31 March 2016

Application Ref 2015/7237/P 4 Tavistock Place, London WC1

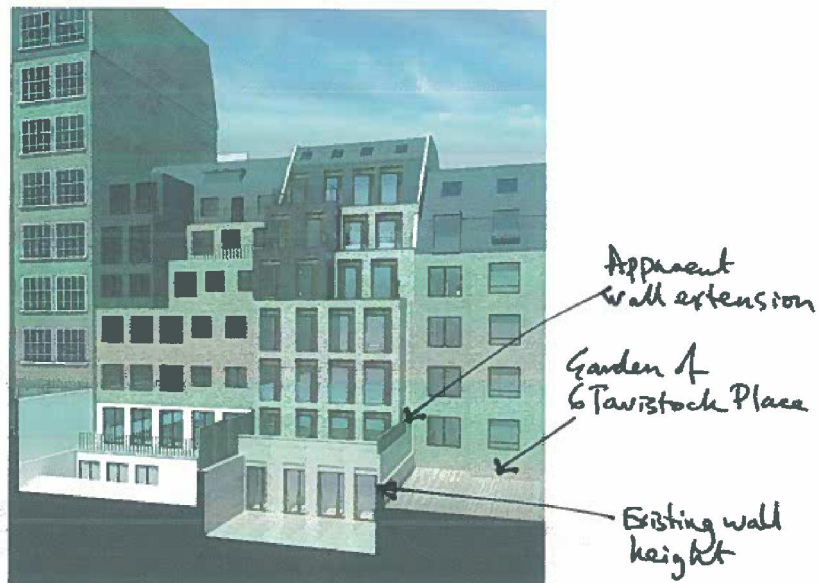
I commented last year when the application for change of use and excavation was first made. I live next door and I was concerned that there appeared to be a higher wall beside my garden. You can see this in the Design and Access Statement page 22 – photo reproduced here. I have marked the current wall height and the apparent extension:

I contacted the architects last year and they said that a higher wall was not part of the plan – see letter attached. I believe that is still the case. But I just wanted to put down a marker that the wall should not be made higher. I would be grateful if you would make sure that this is noted in some way when the application gets approval, as I assume it will.
